MISSOULA COUNTY
INVITATION FOR BID ADDENDUM

IFB NAME: Missoula County Detention Facility Cooling System Upgrade
DUE DATE: July 9, 4:00 p.m., Local Time

ADDENDUM NUMBER: 1 **06-2026-03-A**

Addendum No. 01
Date: July 2, 2026
Project: Missoula County Detention Facility, Cooling System Upgrade
Owner: Missoula County
Architect: Cushing Terrell
306 W Railroad Ave, Ste. 104
Missoula, Montana 59802

1 MECHANICAL SITE PLAN
M003 1" = 20'-0"

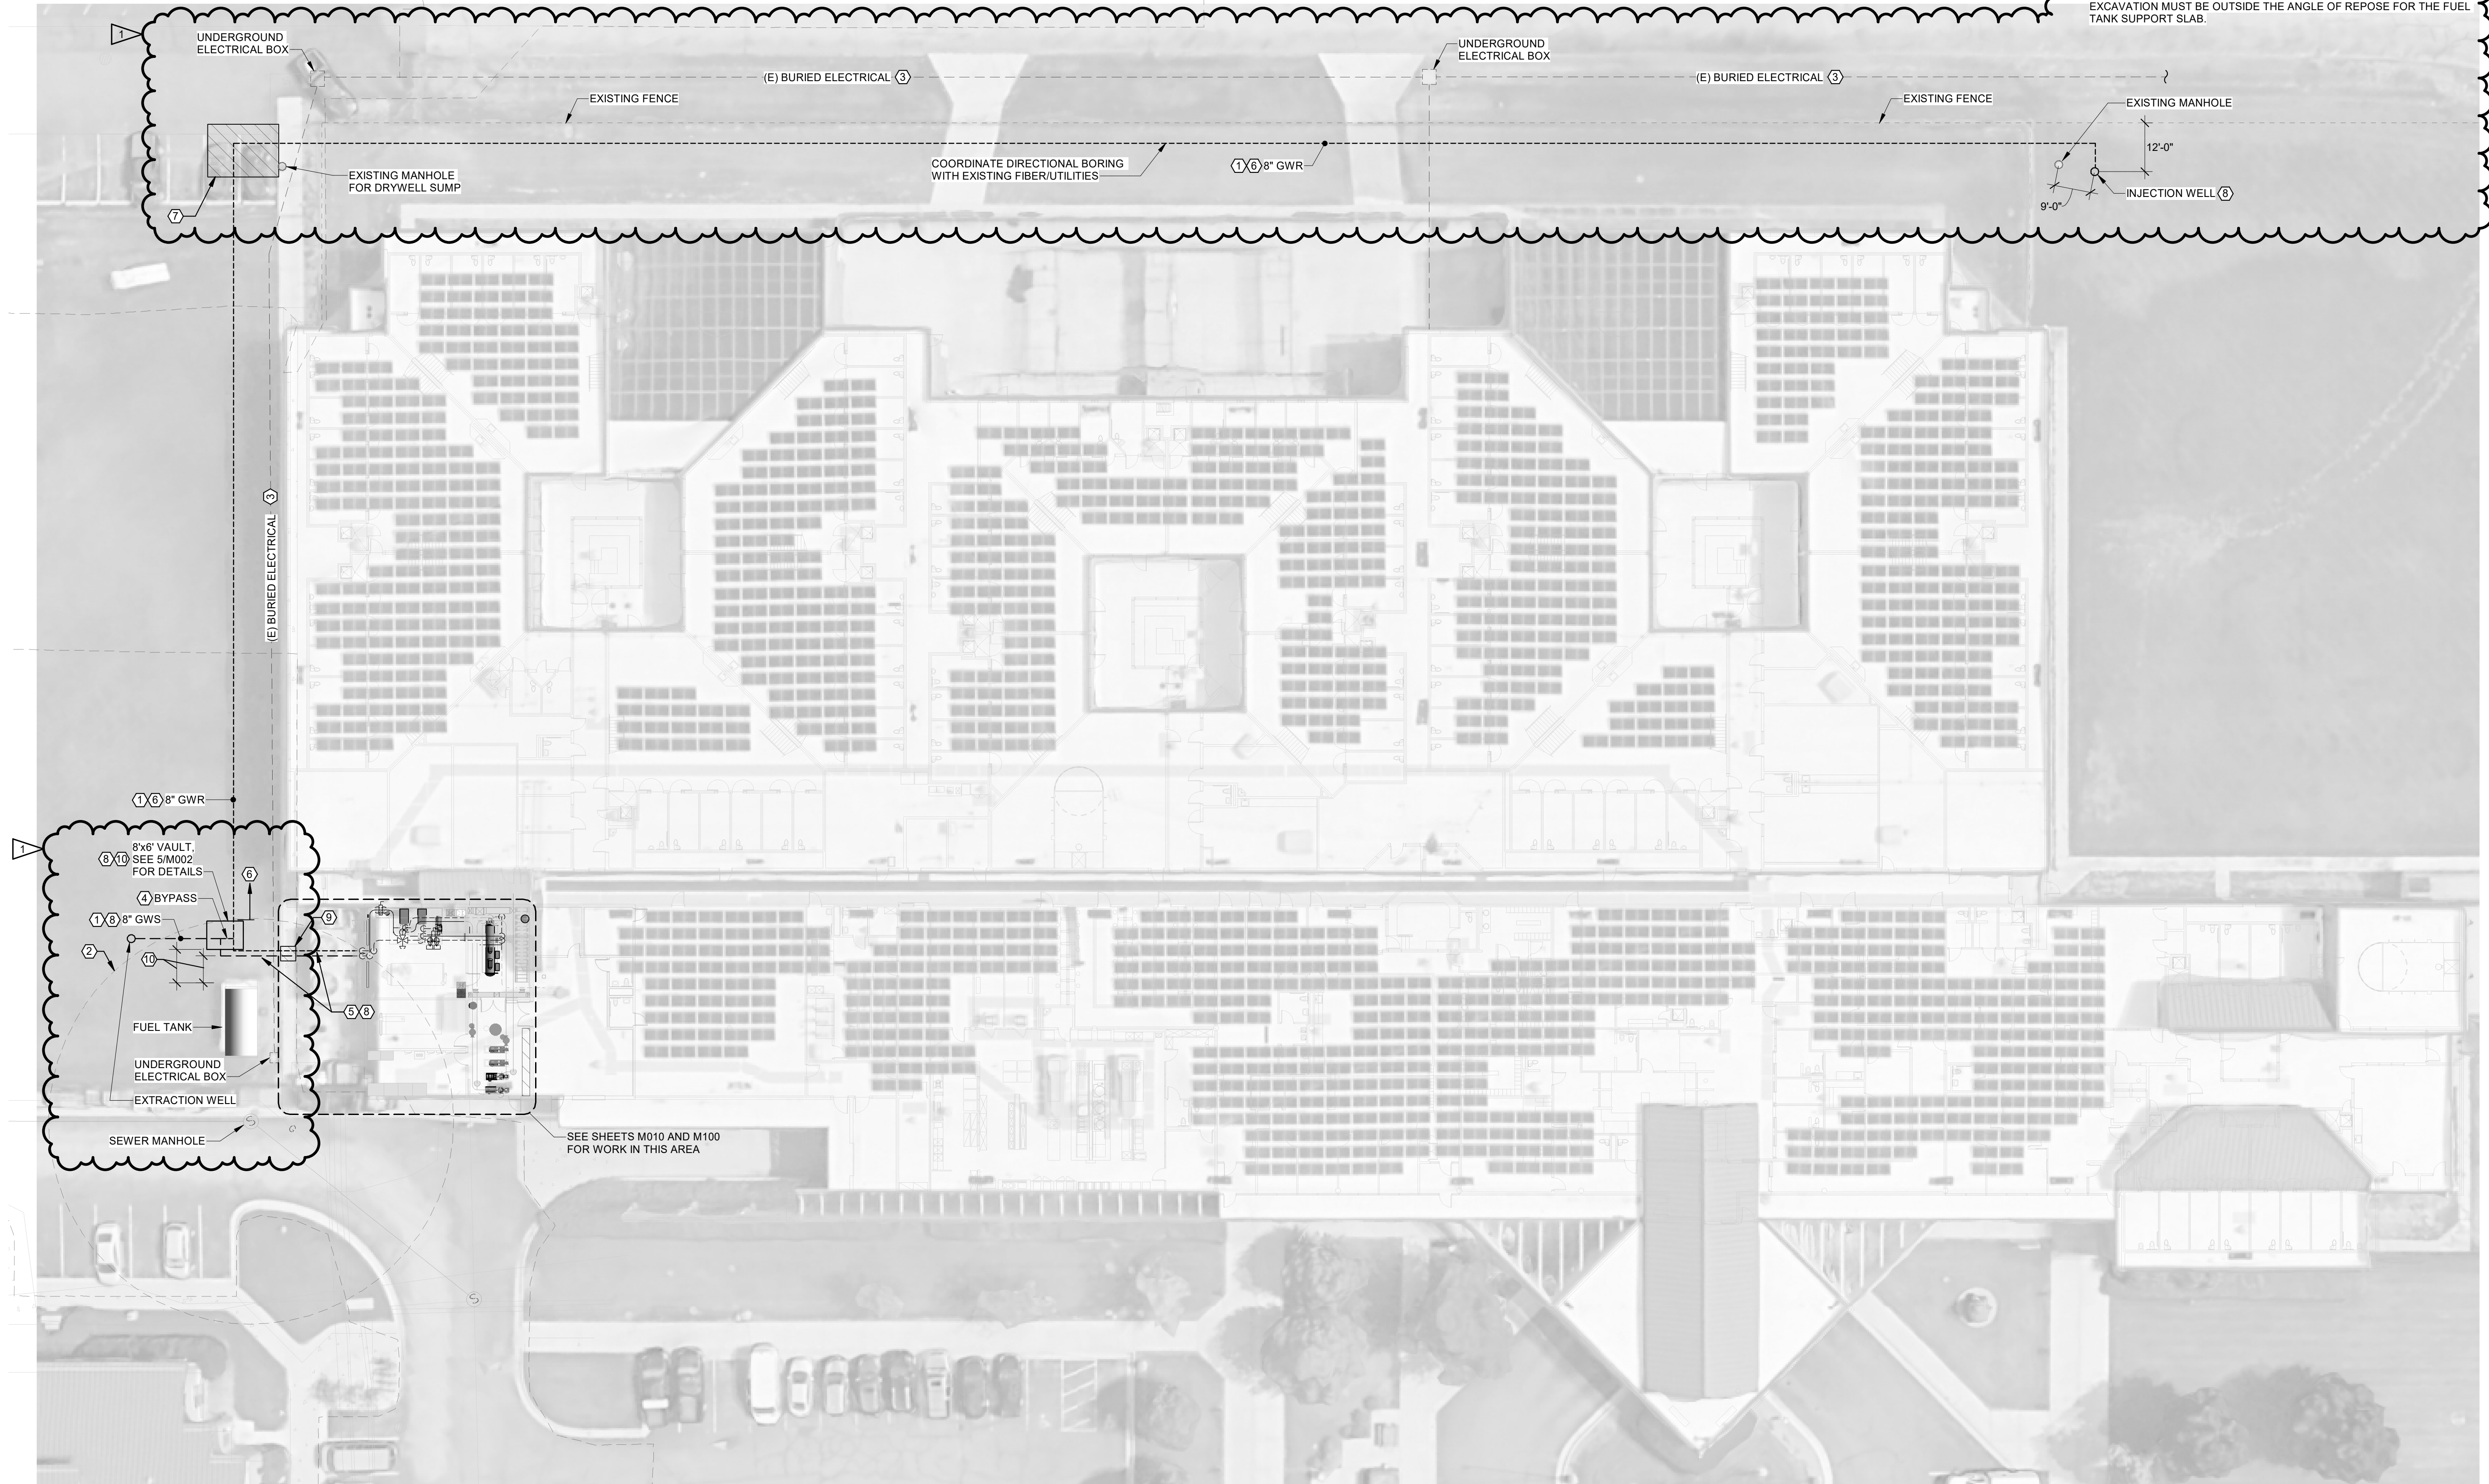
SHEET M003 – MECHANICAL SITE PLAN (see attached revised drawing)

1. ADD: Identification of roof drain sump manhole.
2. MODIFY: Pressure test note.
3. MODIFY: Directional drill path on north side of the building to avoid buried roof drain piping to sumps.
4. ADD: Keynote 10.

A. ENTIRE LENGTH OF BURIED GWS/R PIPING FROM THE SUPPLY WELL TO INJECTION WELL SHALL BE PRESSURE TESTED PRIOR TO CONNECTING TO THE SUPPLY WELL AND INJECTION WELL. SEE SPECIFICATIONS FOR PIPE TESTING PROCEDURE.

10. CONTRACTOR SHALL COORDINATE FINAL VAULT LOCATION TO ENSURE ANY EXCAVATION REQUIRED FOR VAULT OR PIPING INSTALLATION DOES NOT UNDERMINE THE SUPPORT PAD FOR FUEL TANK. EXCAVATION MUST BE OUTSIDE THE ANGLE OF REPOSE FOR THE FUEL TANK SUPPORT SLAB.

1 ENLARGED PLANT MECHANICAL DEMOLITION PLAN
M010 1/4" = 1'-0"

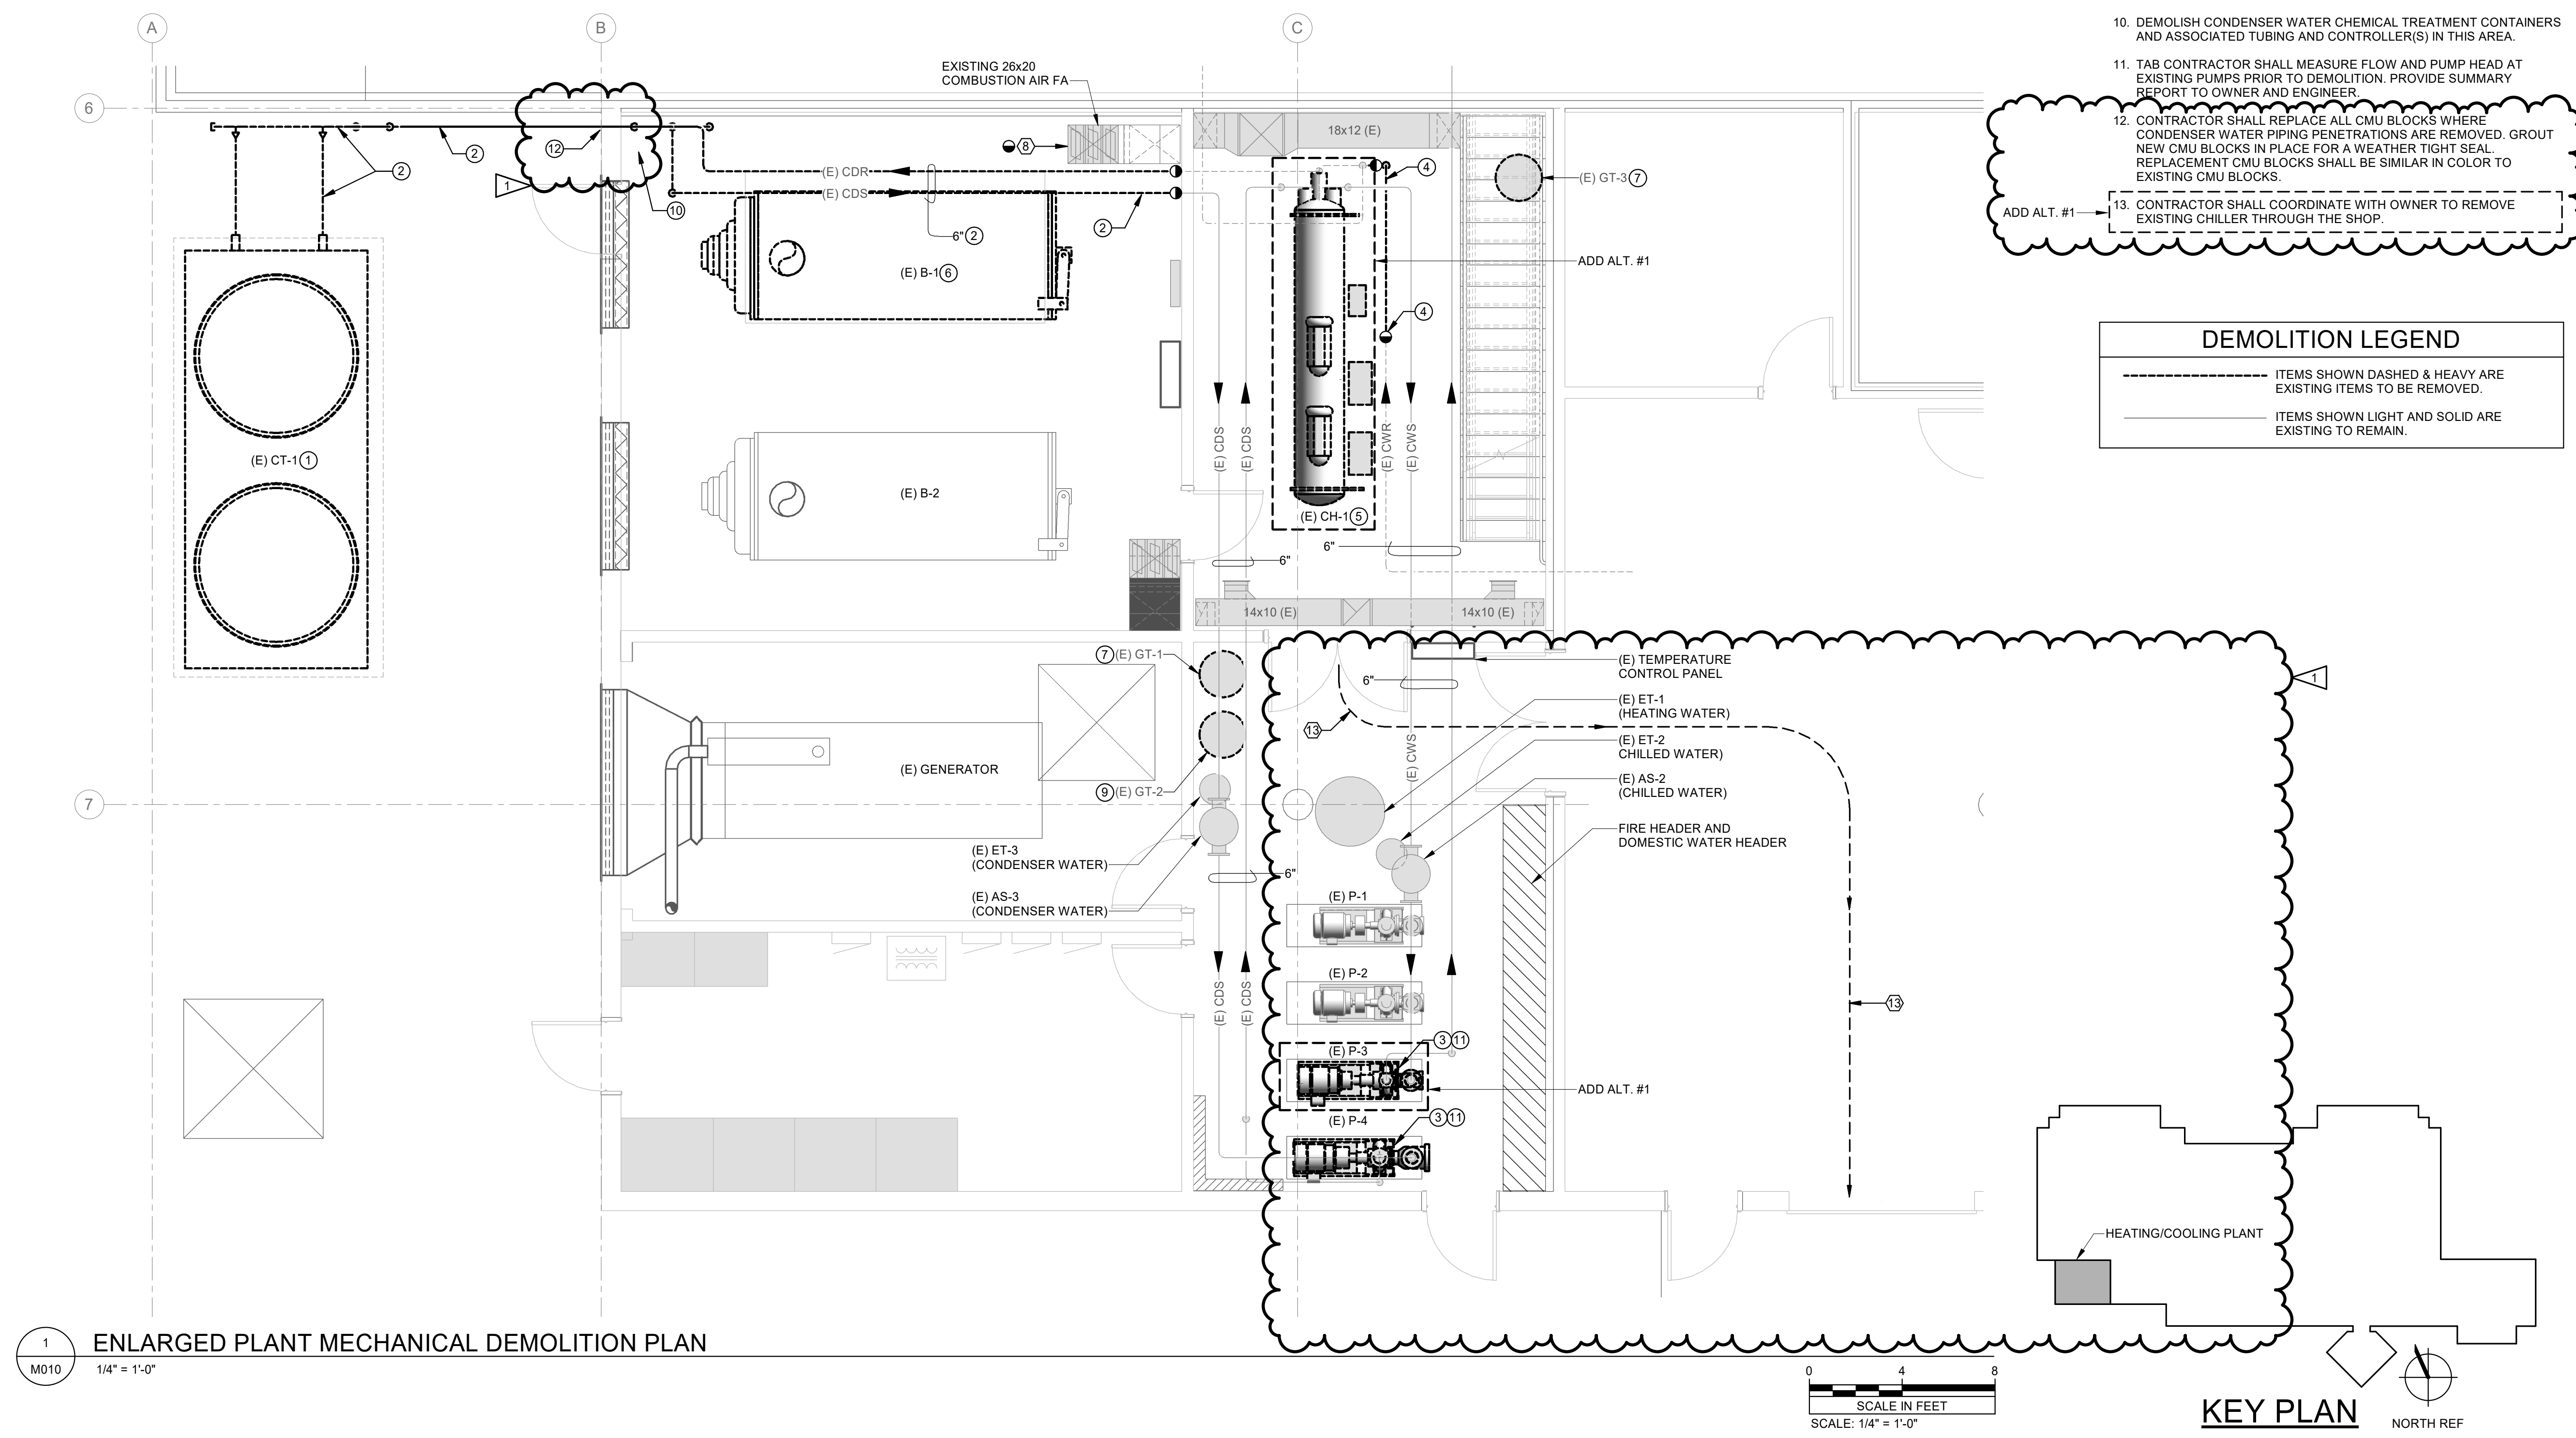
SHEET M010 – ENLARGED PLANT MECHANICAL DEMOLITION PLAN (see attached revised drawing)

1. ADD: Keynotes 12 and 13.
2. CLARIFY: Removal path for demolished chiller.
3. ADD: Description of exterior CMU repair where condenser water pipe penetrations are removed.

- 12. CONTRACTOR SHALL REPLACE ALL CMU BLOCKS WHERE CONDENSER WATER PIPING PENETRATIONS ARE REMOVED. GROUT NEW CMU BLOCKS IN PLACE FOR A WEATHER TIGHT SEAL. REPLACEMENT CMU BLOCKS SHALL BE SIMILAR IN COLOR TO EXISTING CMU BLOCKS.

- 13. CONTRACTOR SHALL COORDINATE WITH OWNER TO REMOVE EXISTING CHILLER THROUGH THE SHOP.
